**PG&E Shepherd Substation Project
Addendum to
Final Initial Study/Mitigated
Negative Declaration**

SCH# 2012051067

March 2013

**Addendum to
Final Initial Study/Mitigated Negative Declaration**

Figure 2.1-1: Proposed New Pole Location

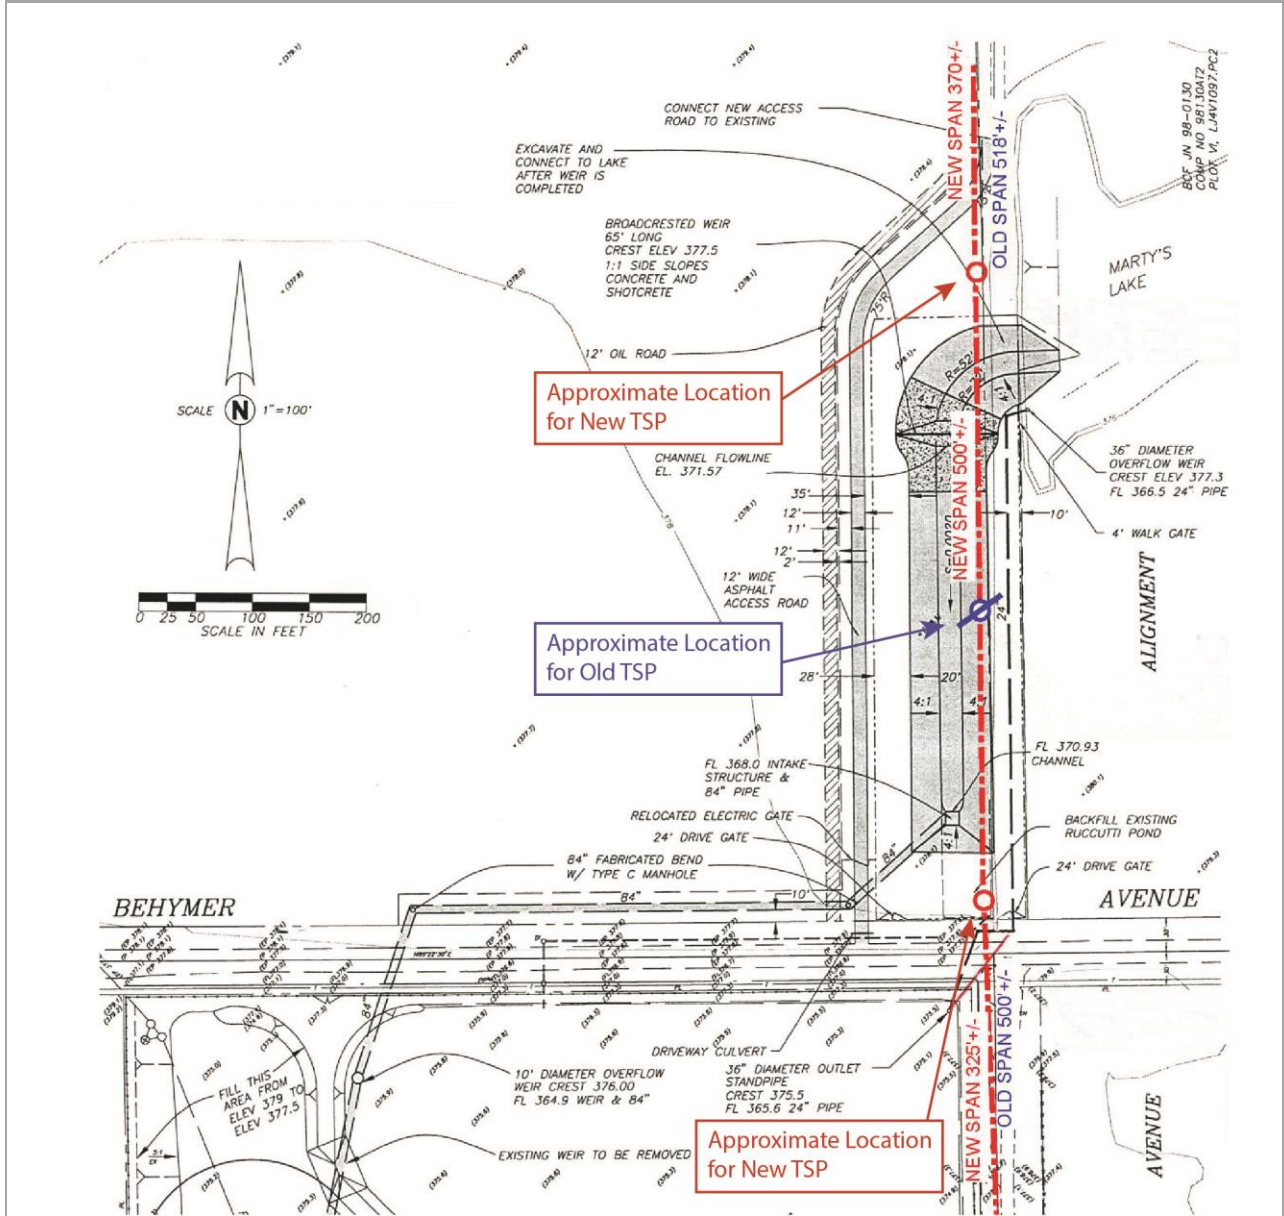
The Final IS/MND prepared in January 2013 included 17 TSPs and one drop-down pole. The number of TSPs would increase to 18 (for a total of 19 power poles) to avoid potential conflicts with the Fresno Metropolitan Flood Control District's (FMFCD's) plans for a flood control channel located north of Behymer Avenue.

The location of the new TSP is shown on Figure 2.1-1. The originally proposed TSP that was located within the FMFCD planned flood control channel (shown in blue on Figure 2.1-1) has been relocated approximately 320 feet north along the alignment so that the power line would span the planned flood control channel. Relocating the pole north to avoid the planned flood control channel increases the power line span. As a result, an additional TSP is required just north of Behymer Avenue.

Figure 2.1-2: Proposed Modifications to Power Line Pole Locations (South)

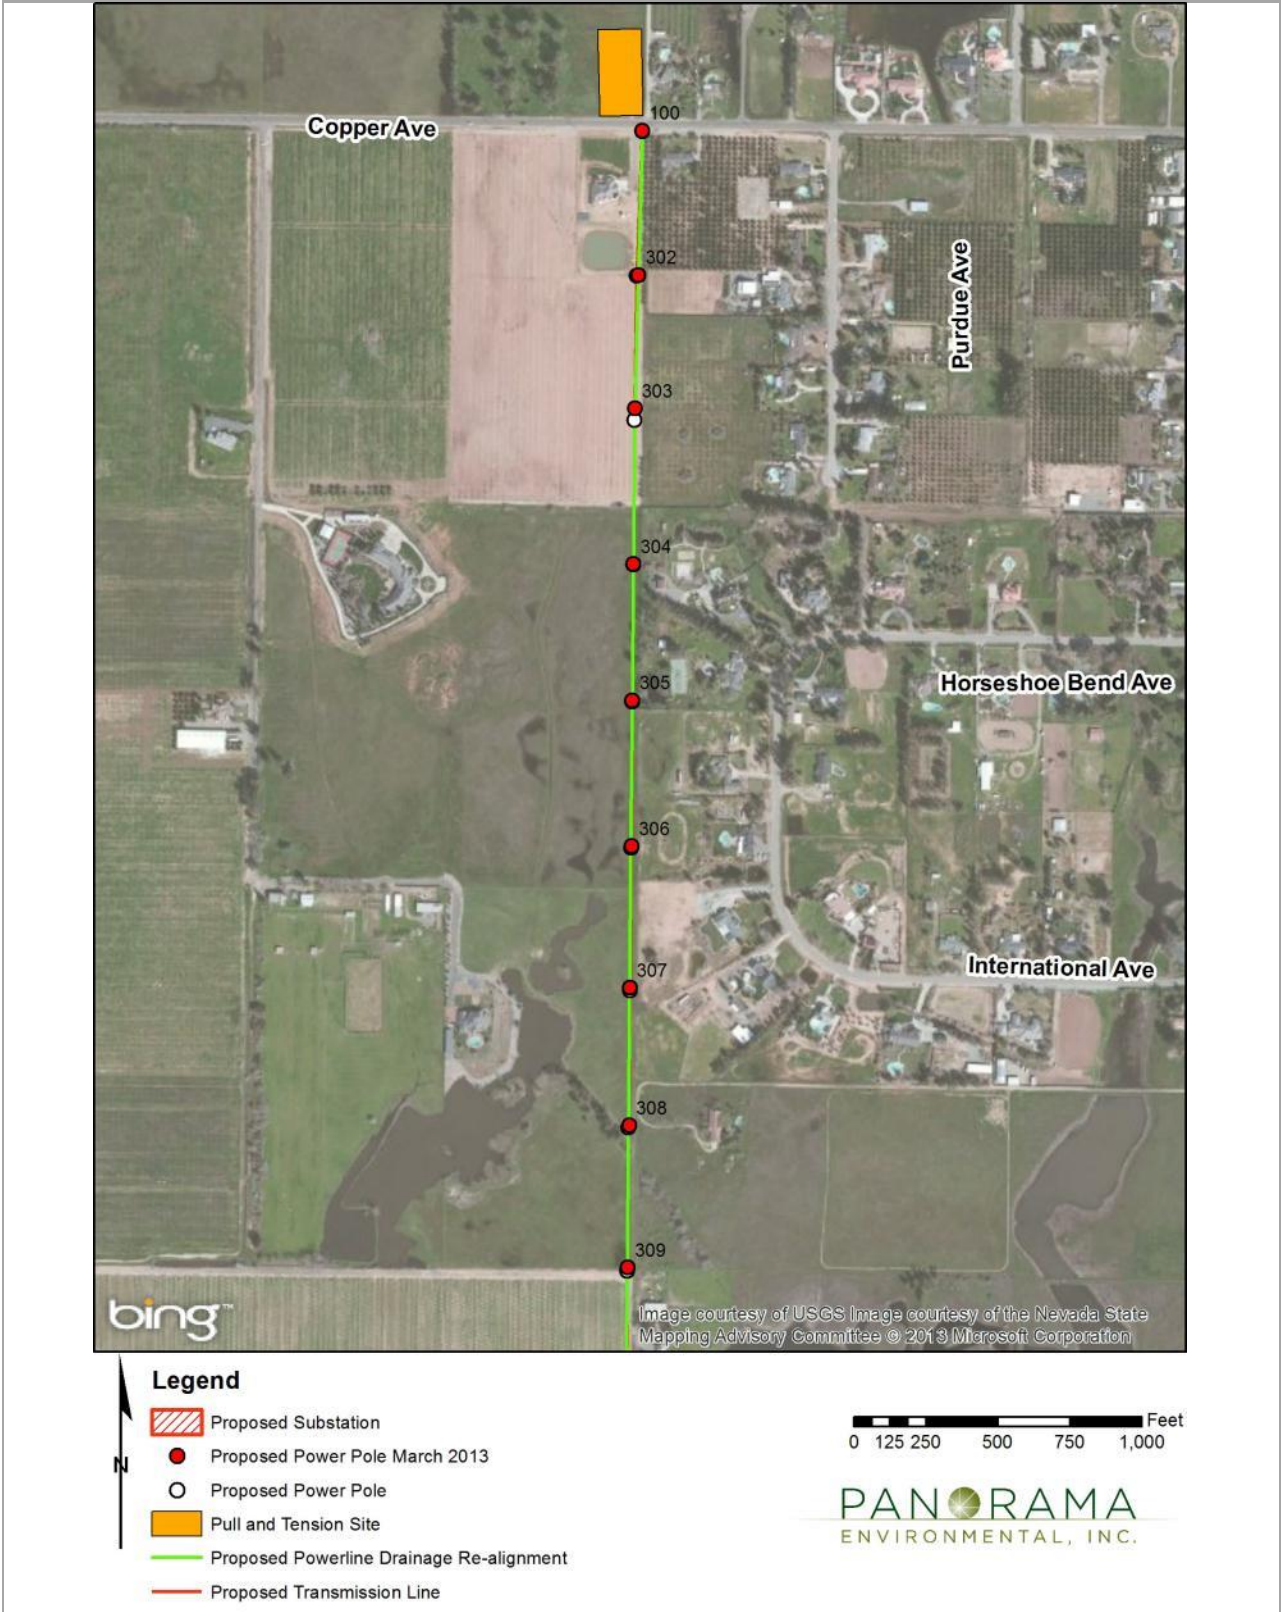
Other proposed TSP locations along the power line alignment would be adjusted to balance out the proposed spans. The current and previously proposed power pole locations are shown on Figures 2.1-2 and 2.1-3.
